UNITED STATES
DEPARTMENT OF THE INTERIOR
BUREAU OF LAND MANAGEMENTFORM APPROVED
OMB NO. 1004-0137
Expires: January 31, 2018**SUNDRY NOTICES AND REPORTS ON WELLS**
*Do not use this form for proposals to drill or to re-enter an abandoned well. Use form 3160-3 (APD) for such proposals.*5. Lease Serial No.
NMNM121473

8. Well Name and No.
W-10 P3 8H9. API Well No.
30-015-4393710. Field and Pool or Exploratory Area
PURPLE SAGE; WOLFCAMP (GAS)11. County or Parish, State
EDDY COUNTY, NM**SUBMIT IN TRIPLICATE - Other instructions on page 2**1. Type of Well
☐ Oil Well ☒ Gas Well ☐ Other2. Name of Operator
CHEVRON U.S.A. INCContact: DORIAN K FUENTES
E-Mail: djvo@chevron.com3a. Address
ATTN DORIAN FUENTES 6301 DEAUVILLE BLVD
MIDLAND, TX 797063b. Phone No. (include area code)
Ph: 432-687-76314. Location of Well (Footage, Sec., T., R., M., or Survey Description)
Sec 3 T26S R27E Mer NMP SESW 603FSL 2066FWL
32.065613 N Lat, 104.180271 W Lon

1) Change from 10M BOPE to 5M BOPE (all equipment will be 10M as per the original submittal, but the annular will be 5M)

2) Utilizing a FMC UH-2 Multibowl wellhead for development wells

Diagram A

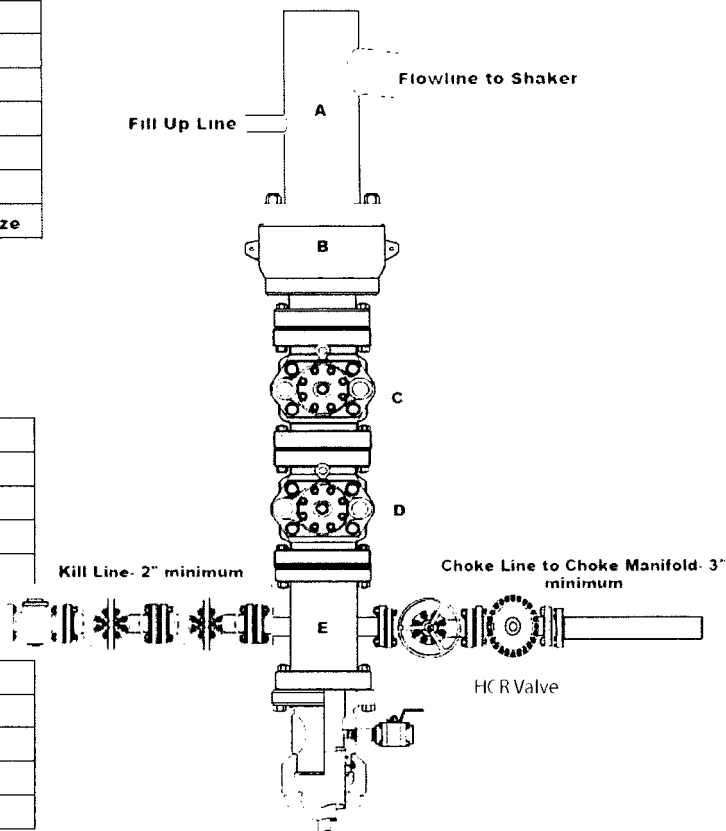
Chevron respectfully requests the ability to change the BOPE rating for the selected well from a 10M system to a 5M system. The maximum mud weight at 10500' for the pore pressure is a 13.0 ppg. The MASP under these assumptions will be 4788 psi. the attached documents below reflect a 5M system BOPE rating and test pressures.

5M system requires an HCR valve, remote kill line and annular to match. The remote kill line is to be installed prior to testing the system and tested to stack pressure.
